ADDENDUM No. 1

**Request for Proposals CS-18-05
AMMONIA PLANT EXHAUST SYSTEM MODIFICATIONS
FOR THE CANOE VALLEY RECREATION CENTRE, VALEMOUNT AND THE
ROBSON VALLEY RECREATION CENTRE, MCBRIDE**

MECHANICAL ADDENDUM

PROJECT NAME:	Canoe Valley and Robson Vally Recreation Center Ammonia Exhausts	ISSUED BY:	B. Erickson
PROJECT No.:	18-1024	NO OF PAGES:	3
ADDENDUM NO.:	01	DATE:	June 20, 2018

1
MSK-1
ROBSON VALLEY REC CENTRE EXHAUST DISCHARGE DETAIL
SCALE: 1" = 1'-0"

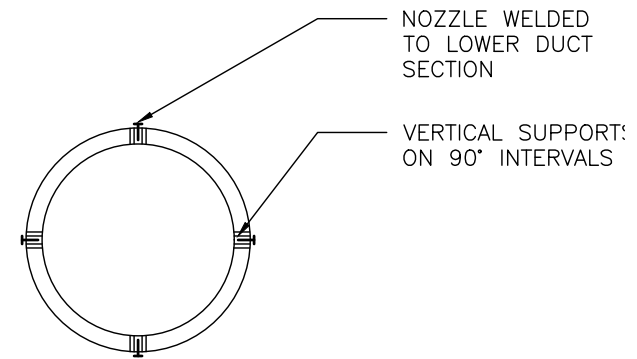
1.2.1 Detail 3 M2 updated on MSK-01.

NOZZLE WELDED TO LOWER DUCT SECTION
VERTICAL SUPPORTS ON 90° INTERVALS

2
MSK-1
CANOE VALLEY REC CENTRE EXHAUST DISCHARGE DETAIL
SCALE: 1" = 1'-0"

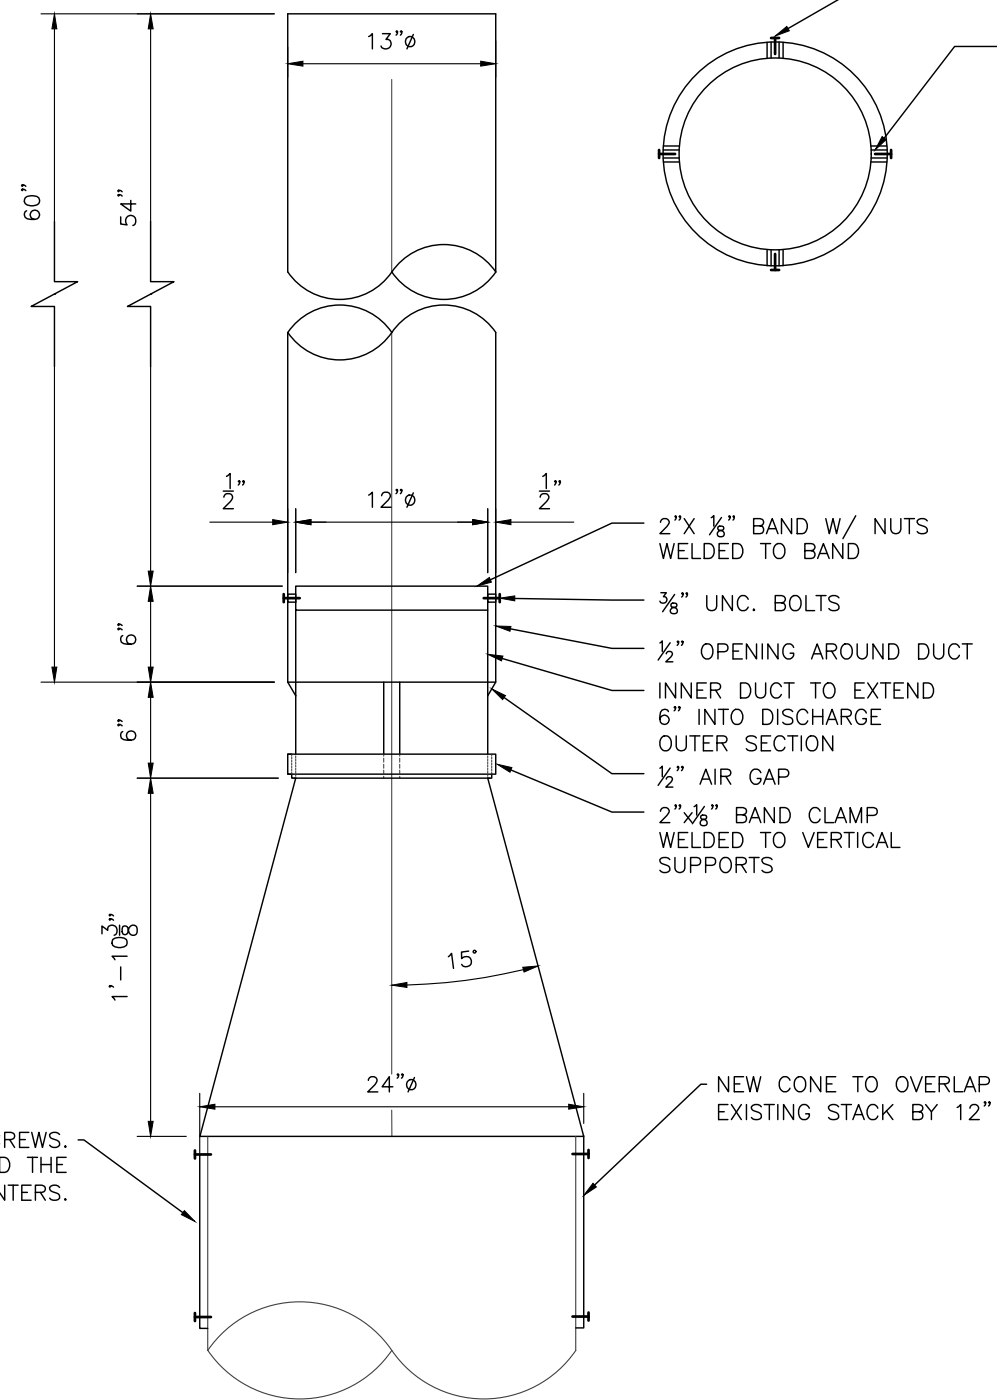
2.2.1 Detail 1 M2 updated on MSK-01.

PROVIDE 2 ROWS OF SCREWS. PROVIDE SCREWS AROUND THE CIRCUMFERENCE ON 12" CENTERS.
